SUBJECT: Application for amends to Licenses DPR-58 & DPR-74, modifying
 "Control Room Emergency Ventilation Sys" & associated bases.

Donald C. Cook Nuclear Plant Units 1 and 2
Docket Nos. 50-315 and 50-316
License Nos. DPR-58 and DPR-74
CONTROL ROOM VENTILATION TECHNICAL SPECIFICATIONS

REASONS AND 10 CFR 50.92 ANALYSES FOR CHANGES TO THE
DONALD C. COOK NUCLEAR PLANT UNIT NOS. 1 AND 2
TECHNICAL SPECIFICATIONS

Figure 1

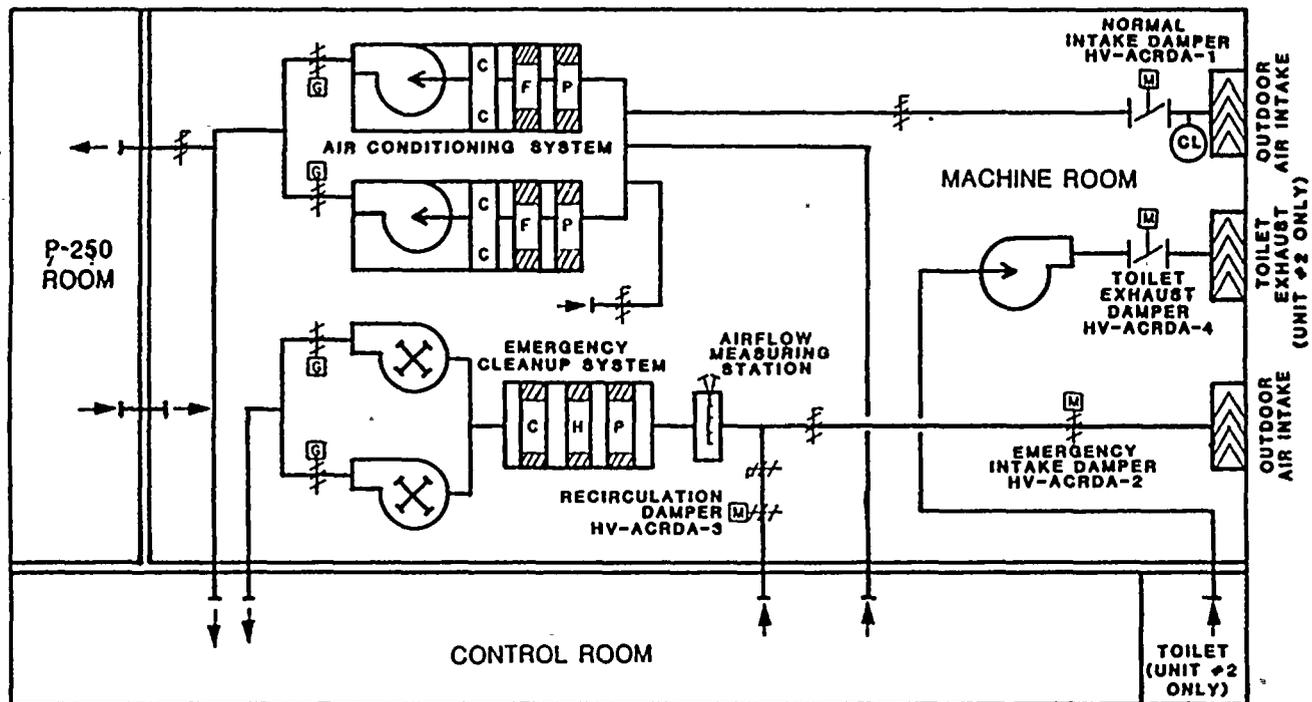
Figure 1 is a simplified flow diagram of the control room ventilation system. Figure 1 also shows the layout of the various rooms that are served by the control room ventilation systems. These rooms include the control room itself, the HVAC machine room (which houses the various ventilation equipment), and the P-250 computer room.

During normal operation of the control room HVAC system, outdoor air is drawn into the system through the normal intake damper. The HVAC system supplies air to the P-250 computer room and to the control room. Air from the

computer room flows to the machine room through a transfer grill. Air returns to the HVAC system from the control room and the machine room. The emergency intake damper and the toilet room exhaust damper are normally open. The recirculation damper will be maintained open in the future to provide protection against its failing to open if it should be closed.

In the event of a safety injection signal from either unit or a high radiation signal from the control room's area radiation monitor, the system would automatically be realigned in the recirculation/cleanup mode. In this mode, the normal intake damper and the toilet exhaust damper would automatically close to prevent unfiltered air from being drawn into the system. The recirculation damper would automatically open (if closed) to provide recirculation capability, and both pressurization fans would automatically start, drawing air through the filter unit. The operator would then turn off one of the redundant fans to ensure that air velocity through the filter unit will provide a minimum iodine residence time of approximately 0.25 seconds. The filter unit includes roughing filters, high efficiency particulate air (HEPA) filters and charcoal absorbers enclosed in a filter housing.

In the radiological mode, the system is designed to provide a flow rate through the filter unit of 6000 cfm \pm 10%. This flow rate is a combination of air recirculated through the recirculation damper and drawn from the outside through the emergency intake damper. Pressurization of the control room envelope is provided by this outdoor air drawn by the pressurization fans. The design of the system is such that a minimum 1/16-inch water gauge (W.G.) pressure would be maintained in the control room. Since the computer room and equipment rooms would see little or no personnel ingress and egress under accident conditions, they are designed to provide a pressure greater than ambient, but potentially lower than the control room itself.

A chlorine gas detector is located in the normal air inlet duct. In the event that chlorine is detected, the ventilation system would be manually realigned from the control room in the isolation mode of operation. This is accomplished by closing the normal intake and the toilet exhaust dampers. The control room pressurization fans are not run, thereby limiting the amount of contaminated

outdoor air that can enter the control room. The emergency intake damper cannot be closed from the control room beyond the setting for the recirculation/cleanup mode. Without the pressurization fans running, air entering through the emergency intake damper is limited to that amount driven by the small differential pressure that may exist between the control room and adjoining areas and the outside atmosphere.
